ADDENDUM NO. 1

EAST TEXAS REGIONAL AIRPORT
SOUTHWEST GA AREA TAXILANE – PHASE I

COUNTY BID No. 2018-815
FAA AIP No. 3-48-0137-45-2018
KSA Project No. GC.107

UTILITY PLAN

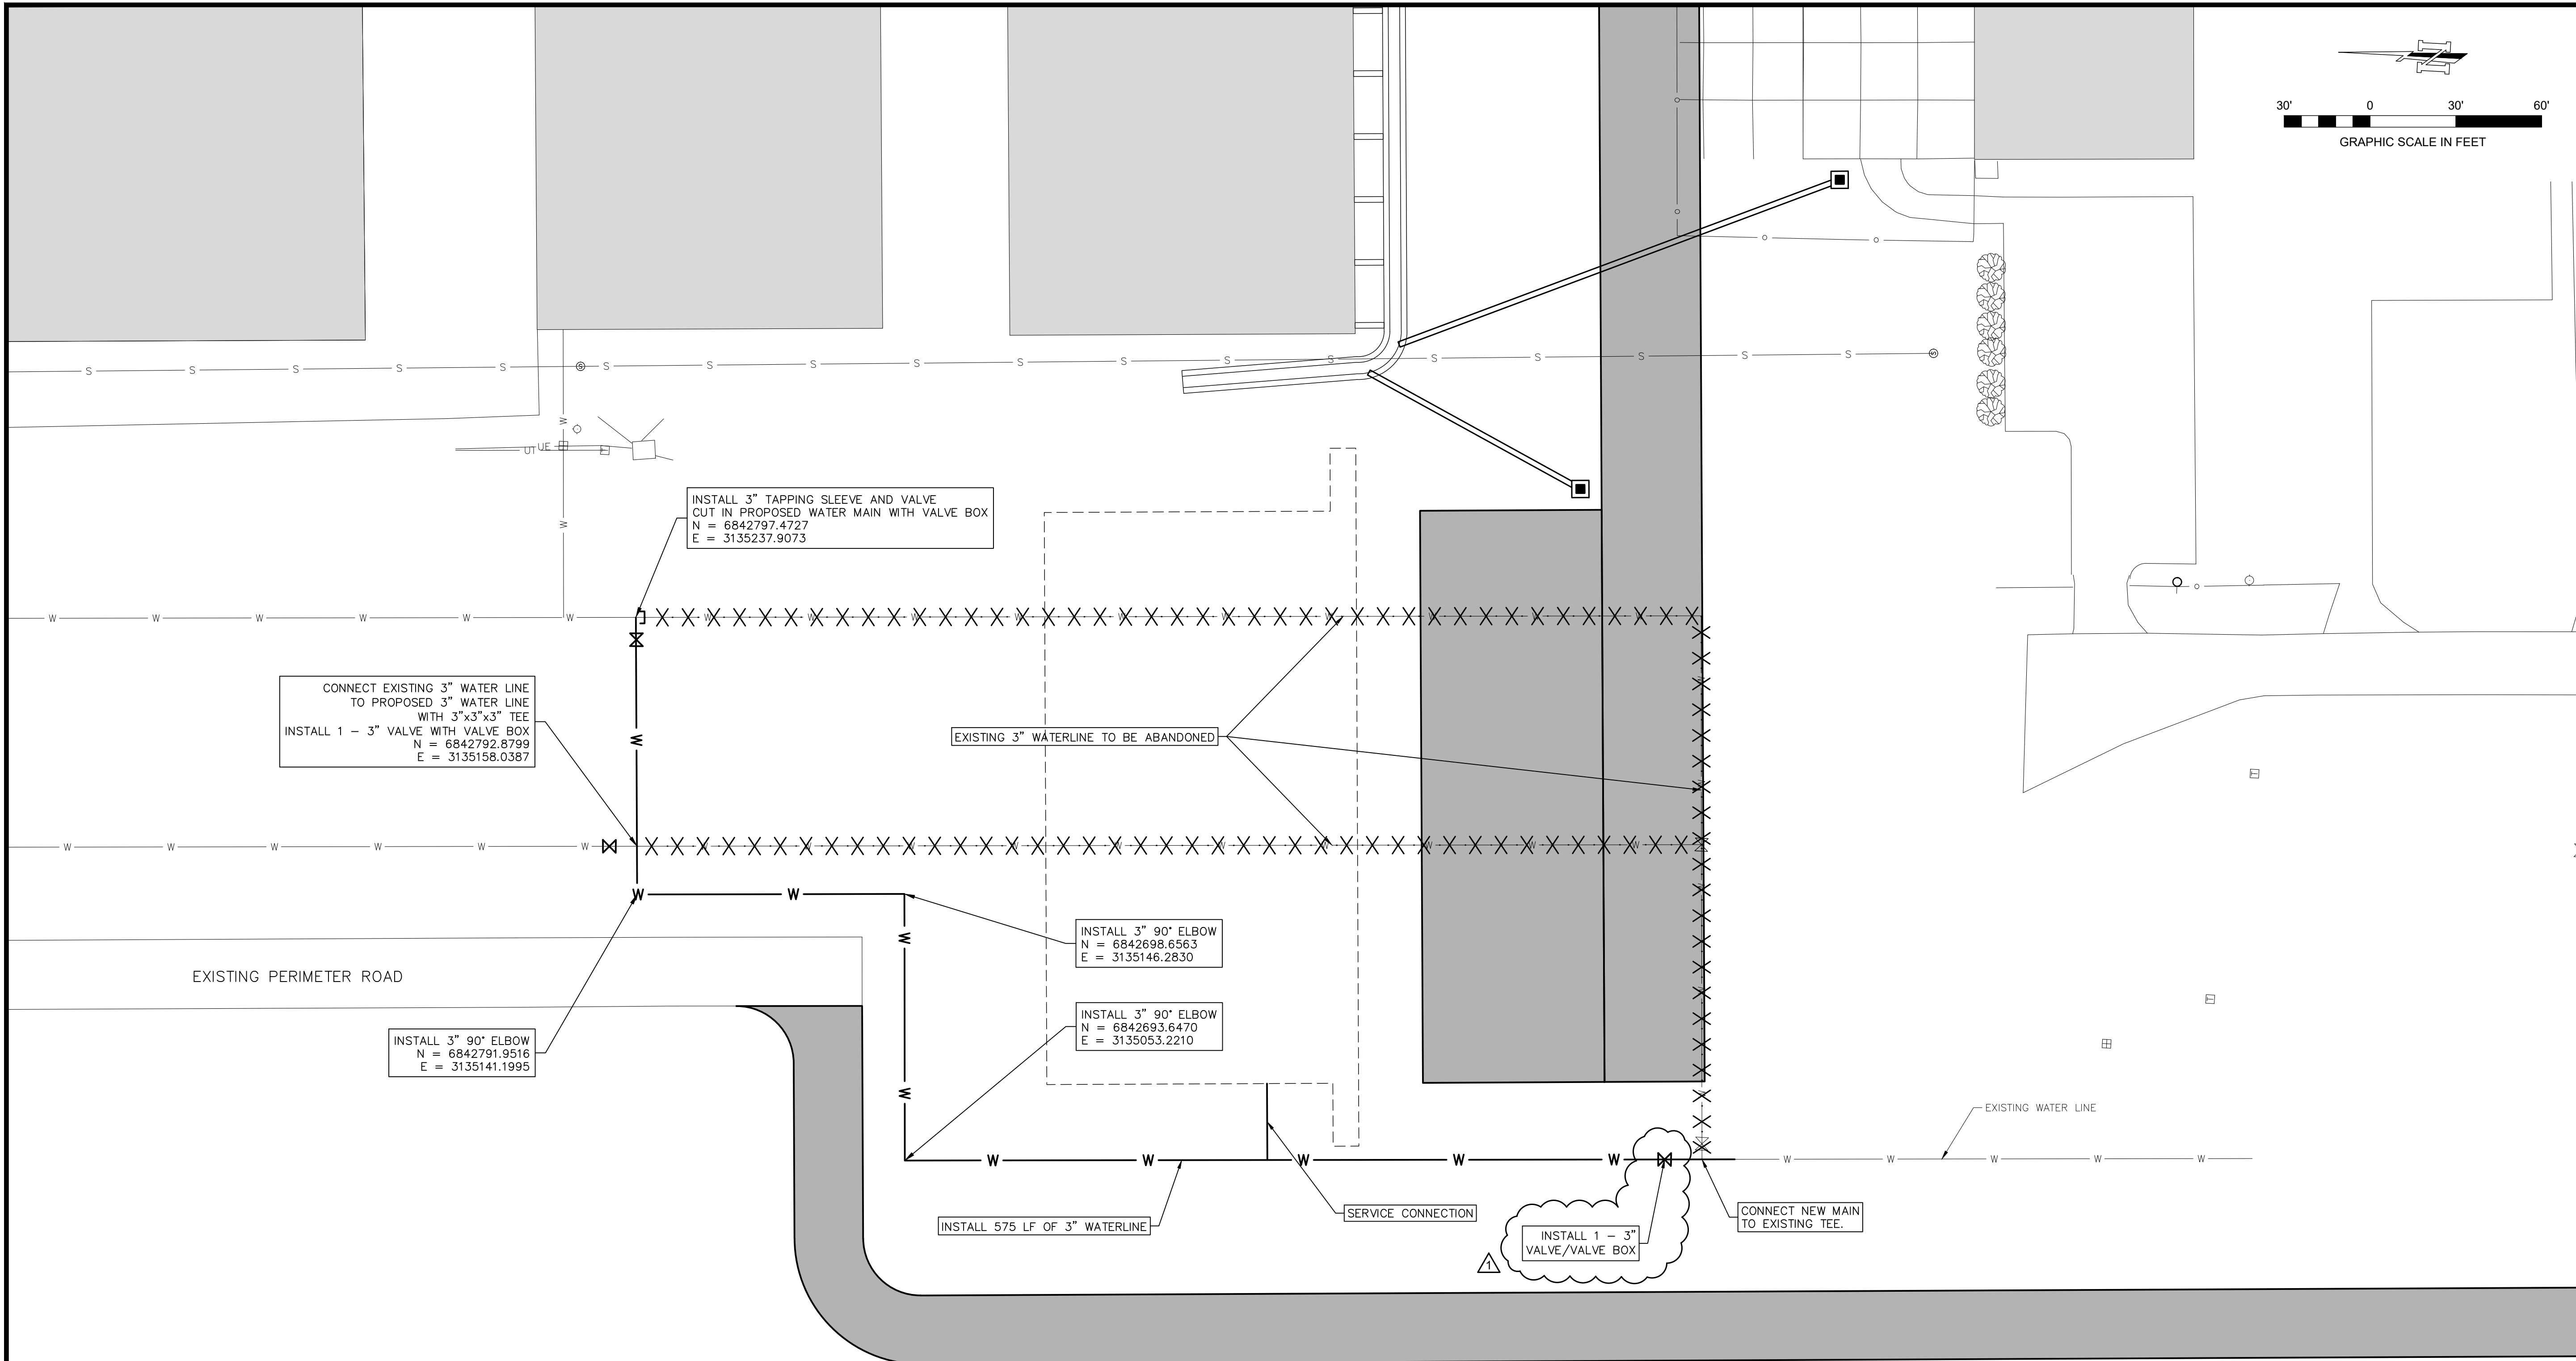
07/18	DATE
ADDENDUM NO. 1	REVISION
MARK	REVISION
MCKENZIE ENGINEERING PROJECTS (C) 2018 CAD 30 SHEETS GC-107-C-UTIL-0001.DWG WATER, 1/17/2018 - 4:46 PM DRAWING PATH NAME LAYOUT PLOT DATE - TIME
